April 13, 2021
Project No. 2312

**RE: Additional Information
Proposed Pine Meadow Road Solar Array "A"
BWC Pine Meadow Brook LLC
Off Pine Meadow Road, Northfield, Massachusetts**

INTERCONNECTION ALTERNATIVE #1

INTERCONNECTION ALTERNATIVE #2

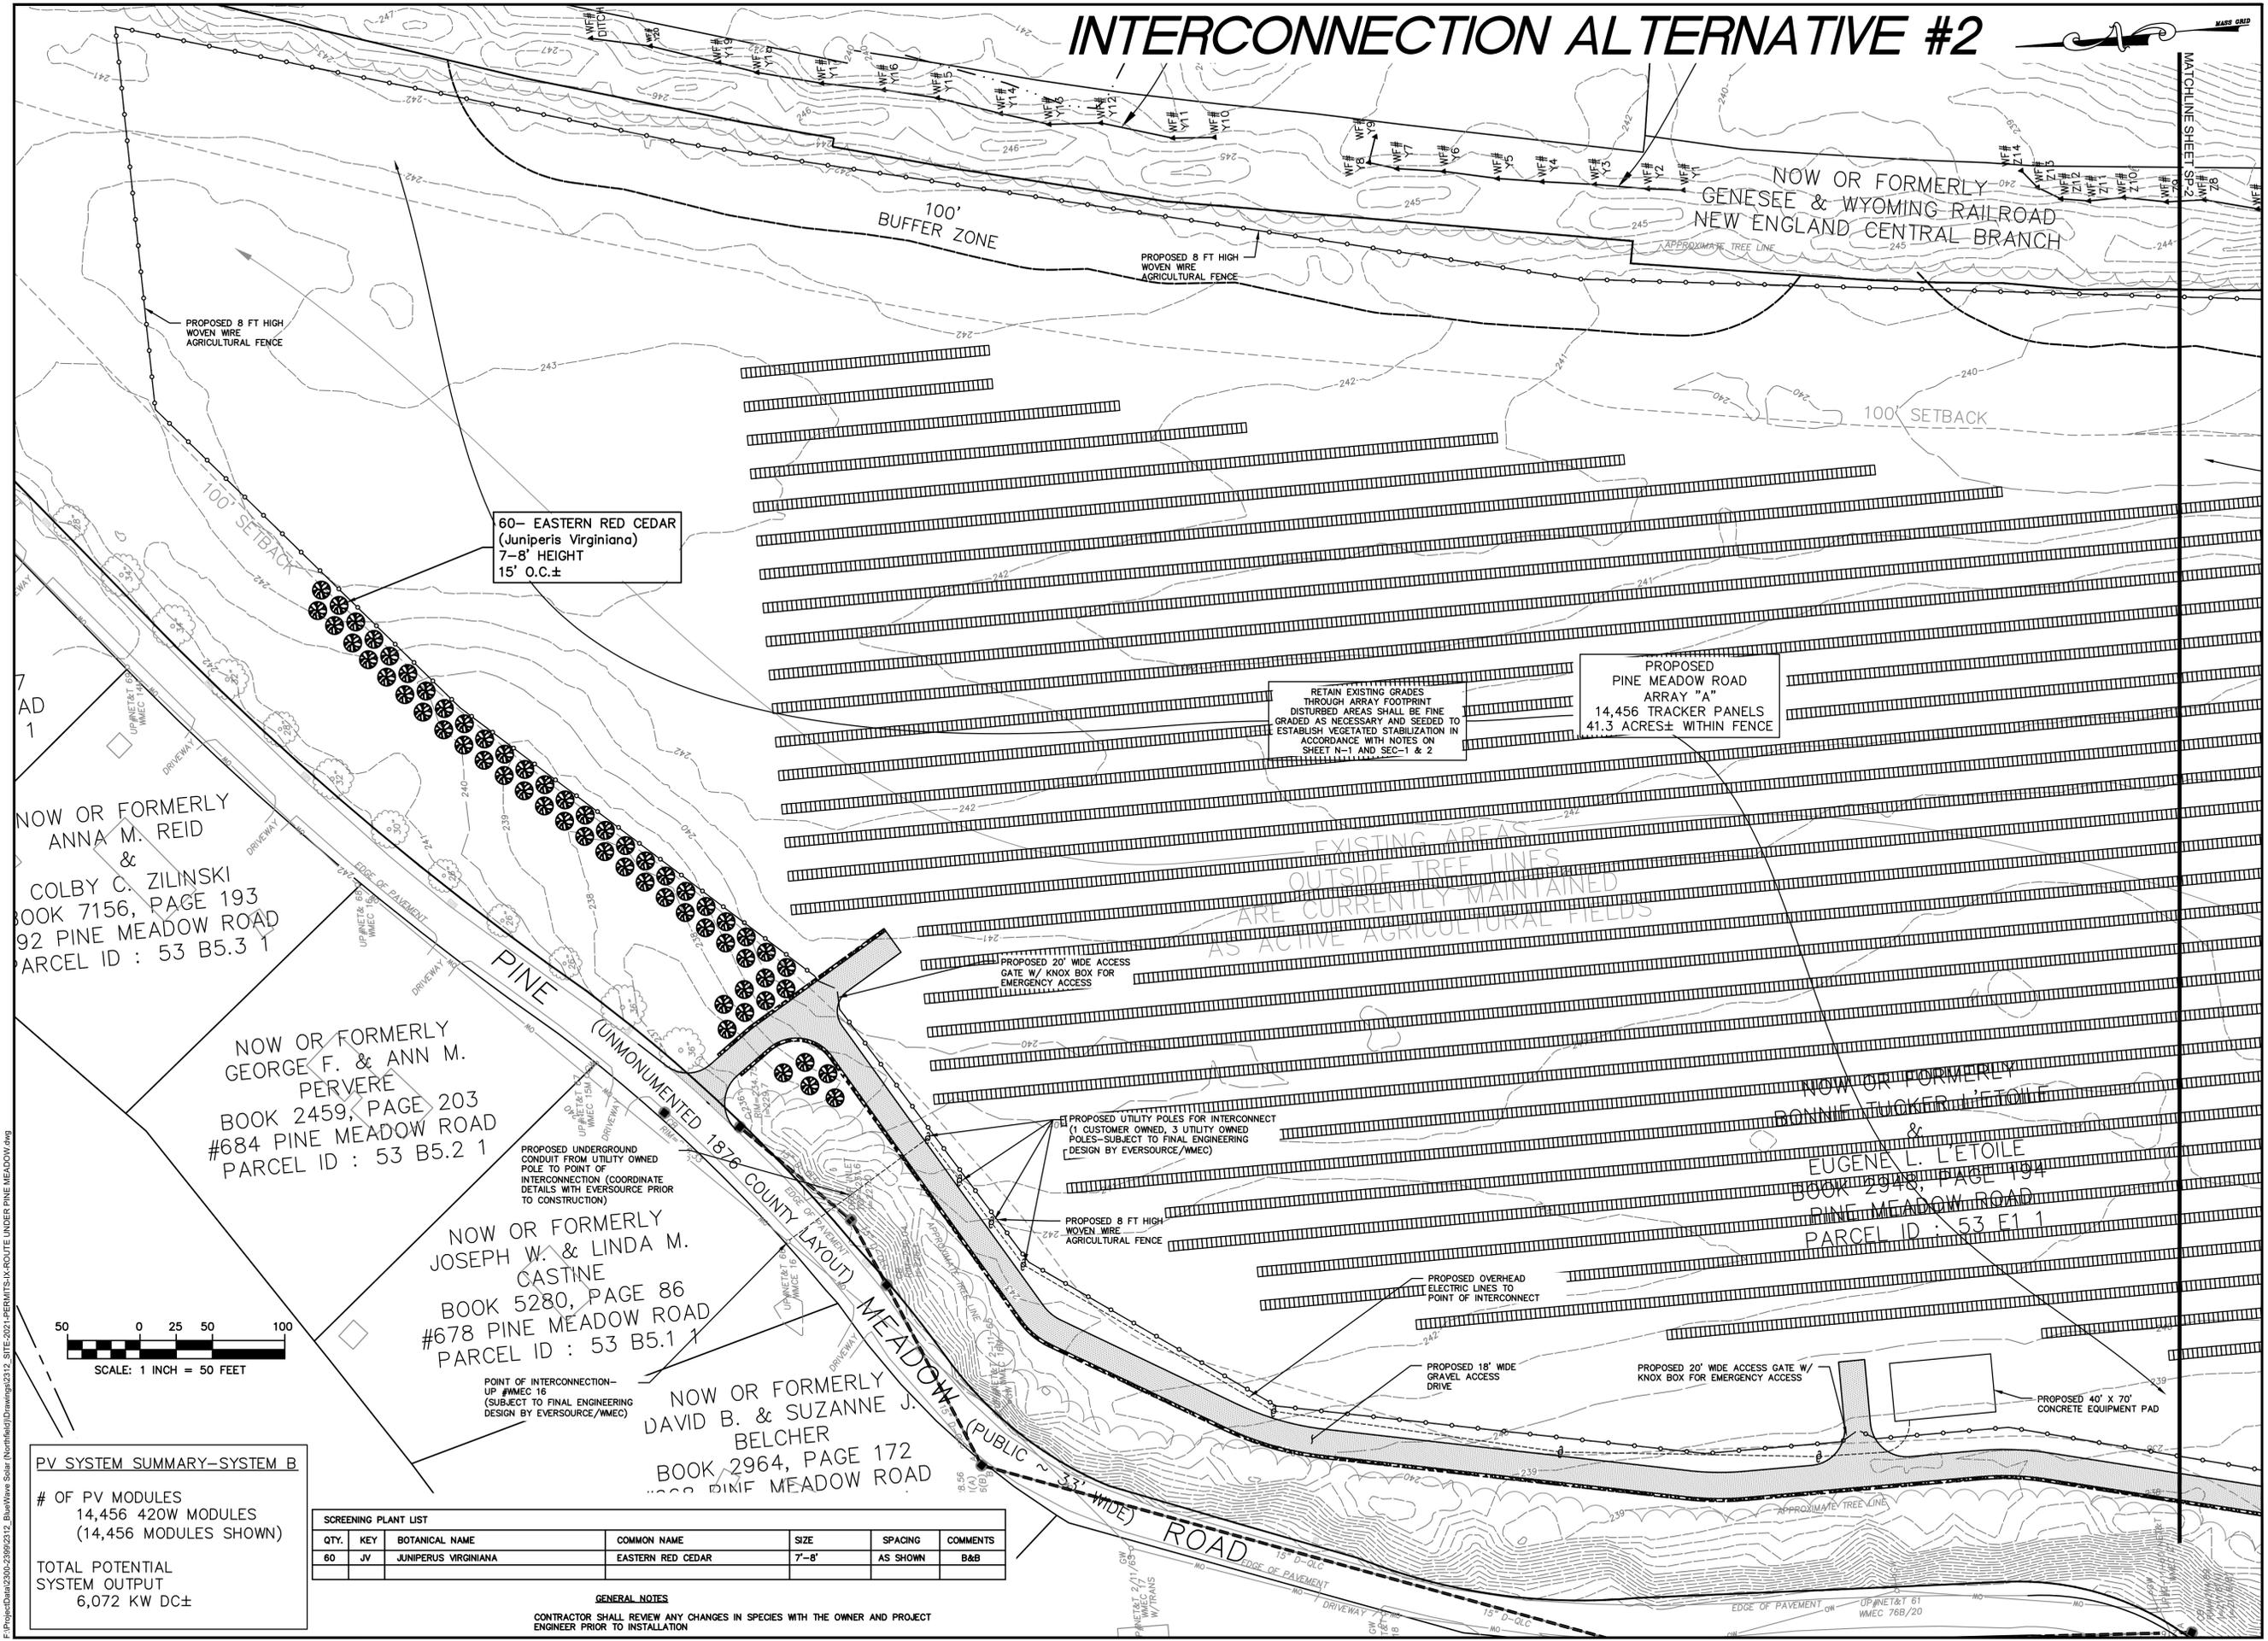
Alternative Interconnection Point 2 – Existing Pole #WMEC 16

The second alternative consists of connecting into an existing pole along the westerly side of Pine Meadow Road, one utility pole south of the previously proposed point of interconnection. Pole #WMEC 16 is located approximately 150' south of the existing driveway at 678 Pine Meadow Road within the Town layout. For this alternative the applicant would interconnect to Pole #WMEC 16 with an underground utility conduit running under Pine Meadow Road and through the existing berm to a proposed utility pole line located on the easterly side of the berm along the previously proposed access driveway. There would be no new utility poles located within the Pine Meadow Road layout or on the roadway side of the existing berm. The new poles would be located on the high side of the berm along the proposed access driveway, hidden from view from Pine Meadow Road by the existing vegetation. For this alternative, the proposed access driveway would remain the same as previously proposed, however there would be no utility poles in the vicinity of the entrance to the facility across from 678 Pine Meadow Road, which would result in a reduced visual impact to the neighboring properties.

Revisions			
No.	Description	Date	Appvd.
2	REVISED PROPOSED INTERCONNECT DETAILS	4/12/21	RRR
1	REVISED PROPOSED INTERCONNECT DETAILS	2/23/21	RRR
